MIDDLE BAY MARINE SUBDIVISION

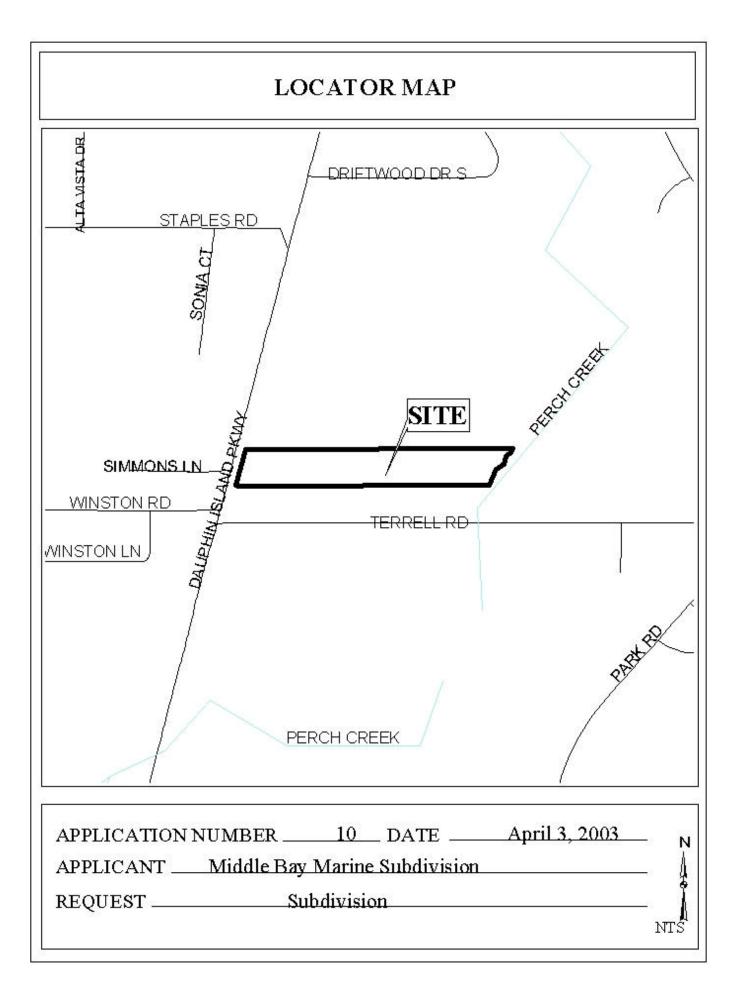
The plat illustrates the proposed 9.6 acre±, 1 lot subdivision which is located on the East side of Dauphin Island Parkway, 190'± North of Terrell Road. The subdivision is served by city water and sanitary facilities.

Dauphin Island Parkway, which has an existing right-of-way of 115', is in compliance with the right-of-way requirement of the Major Street Plan component of the Comprehensive Plan. Given the existing development along this section of Dauphin Island Parkway, development of service roads is not practical; therefore, a limitation on the number of curb cuts would be an acceptable method of access management. With less than 300' of frontage, limiting the site to one curb cut would be appropriate.

There is some discrepancy regarding the ownership of a 50' strip along Perch Creek. The applicant's deed indicates that this strip is a City of Mobile drainage easement. However, the Tax Assessor's map indicates it as a separate parcel owned by the City of Mobile. The City Real Estate office has a copy of a 1967 document whereby payment was made for the condemnation of the parcel. As this parcel is included in the proposed subdivision, this issue should be resolved prior to consideration of the application.

Based on the preceding, it is recommended that this application be held over until April 17, to be considered with the pending PUD application.
